RE: Project No. 35077 – Pedernales Electric Cooperative, Inc.’s Transmission Contract Filing Pursuant to Subst. Rule 25.195(e)

**FIRST AMENDMENT
to the
Interconnection Agreement**

**Exhibit “C”
Interconnection Details**

**CORRECTION TO THE FIRST AMENDMENT
to the
Interconnection Agreement**

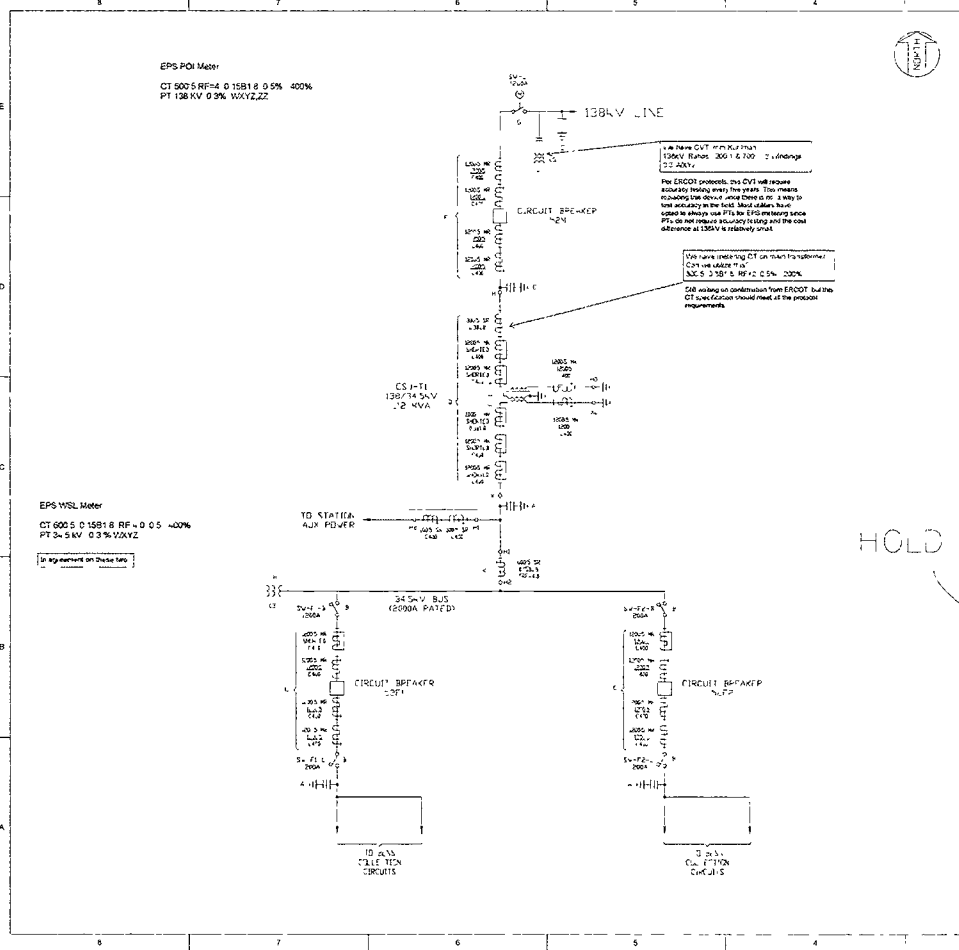
WHEREAS, PEC and Generator wish to amend the Agreement to remove and replace Exhibit C, Interconnection Details, in its entirety

1. Exhibit C, Interconnection Details, is removed and replaced in its entirety with the Exhibit C attached hereto and incorporated herein
2. All other terms and conditions of the Agreement not hereby modified shall continue in full force and effect

- B) The Transmission Service Provider shall, in accordance with ERCOT Requirements and Good Utility Practices, install, own, operate, inspect, test, calibrate, and maintain primary and back up ERCOT Polled Settlement (EPS) meters located at North Fork Substation. The location of the meters are denoted on the one-line attached as Exhibit C1.

- C) Generator shall provide suitable space within the North Fork Substation for the TSP-specified enclosure for the EPS meters.
 - D) The Generator shall install, for TSP’s use, adequately rated instrument transformers to accurately meter the Generator’s facilities. The location of the instrument transformers is denoted on the one-line attached as Exhibit C1.

Exhibit "C3"
Interconnection Detail

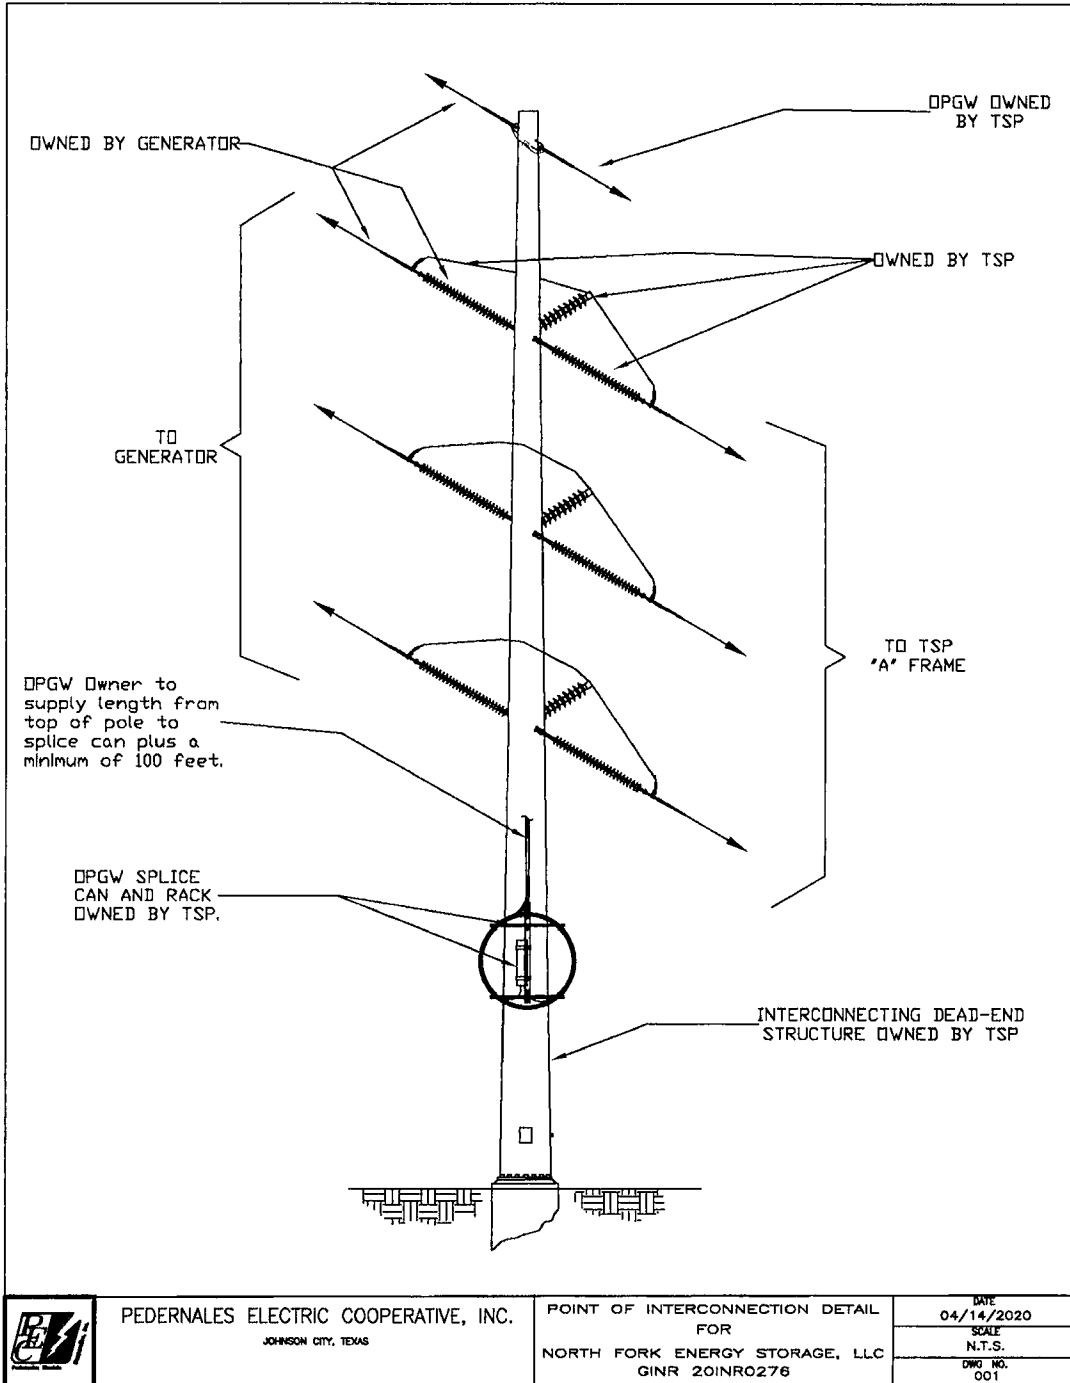
- 1) Name: North Fork Energy Storage, LLC (North Fork Energy Storage) Interconnection
- 2) Point of Interconnection Location: The Point of Interconnection will be at the first transmission pole located outside PEC’s Andice Substation (“TSP substation”) located in Williamson County, TX as shown in Exhibit C1, Exhibit C2, and Exhibit C3.
- 3) Delivery Voltage: 138-kV
- 4) Number and Size of Generating Units: The Plant is a Battery Energy Storage System (“BESS”) facility with one Point of Interconnection to the grid. The nominal Plant rating will be approximately 100.49-MVA of AC power with a maximum rating of 100 MW at the Point of Interconnection comprised of 33 inverter units.
- 5) Type of Generating Unit

- 1) Name: North Fork Energy Storage, LLC (North Fork Energy Storage) Interconnection
- 2) Point of Interconnection Location: The Point of Interconnection will be at the first transmission pole located outside PEC’s Andice Substation (“TSP substation”) located in Williamson County, TX as shown in Exhibit C1, Exhibit C2, and Exhibit C3.
- 3) Delivery Voltage: 138-kV
- 4) Number and Size of Generating Units: The Plant is a Battery Energy Storage System (“BESS”) facility with one Point of Interconnection to the grid. The nominal Plant rating will be approximately 115.8-MVA of AC power with a maximum rating of 100 MW at the Point of Interconnection comprised of 33 inverter units.
- 5) Type of Generating Unit
